Product Change Notice (PCN)

Subject: Assembly materials change for R8C/L3x LFQFP 100pin package products

Difference of specification (R8C/L3Ax LFQFP 100pin)

MCP-AB-22-0133

Material change items

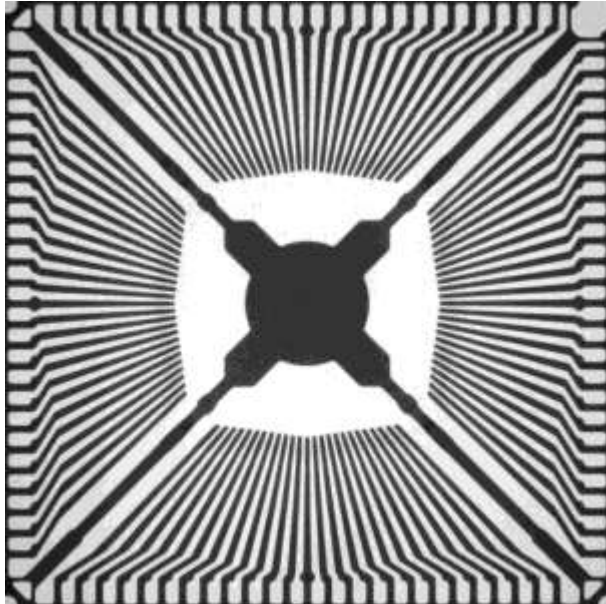
Item		Before change	After change
Lead frame	Shape	Shape is different.	
	Material	No change	
Mold resin	Material	Epoxy resin A * (halogen-free)	Epoxy resin A or B * (halogen-free)

* Although there are material changes, the combination after the change has a track record of mass production, and there is no change in reliability and characteristics.

Lead frame shape

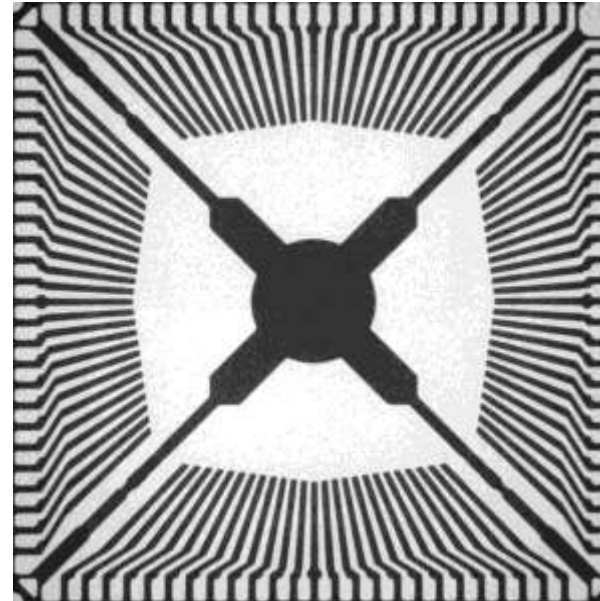
14×14mm 0.5mm pitch 100pin LFQFP lead frame

Consolidate into certified and proven lead frames.

Before change: “**Frame A**”

After change “**Frame C**”
